YAN YEAN ROAD UPGRADE
STAGE 2

YOUNGS ROAD DESIGN UPDATE

PREFERRED DESIGN

Youngs Road roundabout

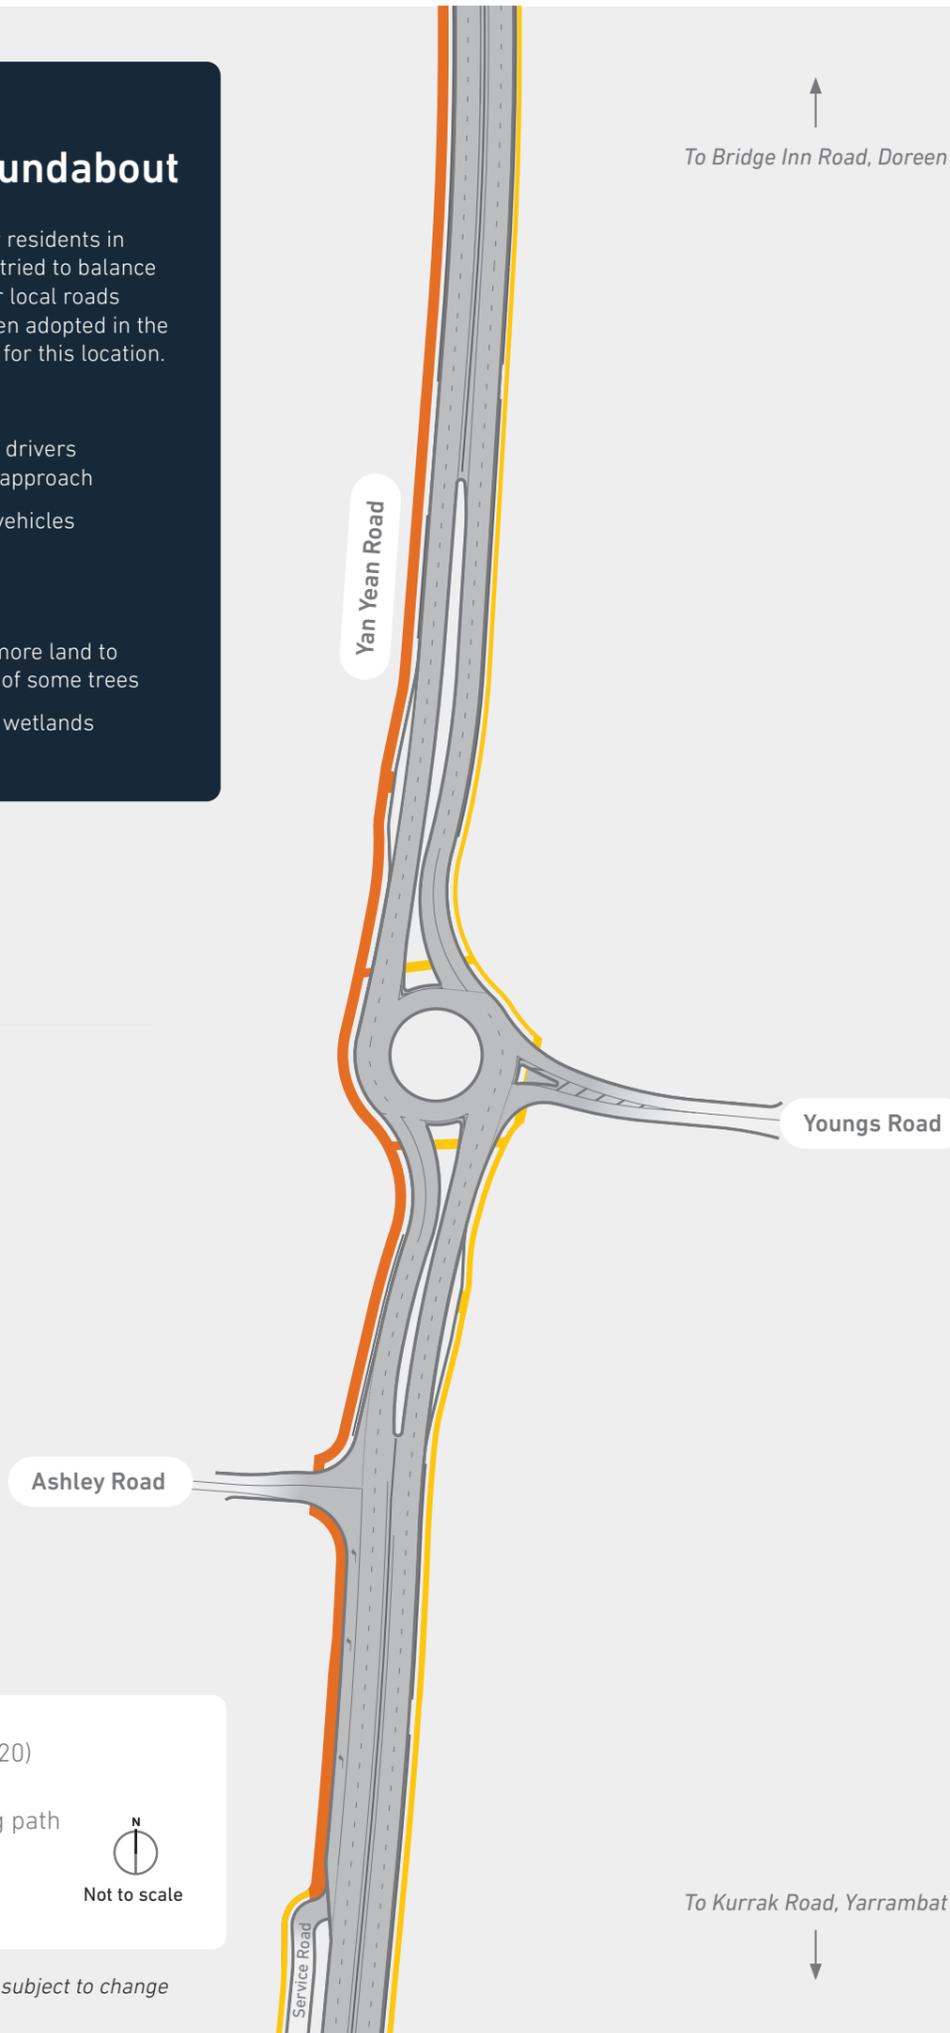
The initial design included dedicated U-turn bays between Youngs Road and Ashley Road to provide road users with additional opportunities to turn around.

After careful consideration and engagement with the local community, we've updated the design to include a roundabout at the intersection of Youngs Road and Yan Yean Road.

This roundabout replaces the proposed U-turn bays and provides improved opportunities for road users with large and heavy vehicles to access nearby businesses and community precincts.

Taking those considerations into account, we've replaced the U-turn bays near Youngs Road with a new roundabout at the intersection of Youngs Road and Yan Yean Road. This will greatly improve access and provide better and safer U-turn opportunities for these types of vehicles.

We understand that access for residents in the area will change, so we've tried to balance traffic flow and safe access for local roads in the area. This option has been adopted in the design as the preferred option for this location.

- Safer U-turn opportunity as drivers are required to slow on the approach
- Caters for large and heavy vehicles and trailer U-turns

- Larger footprint, requiring more land to build including the removal of some trees
- Minor impact to man-made wetlands in the area
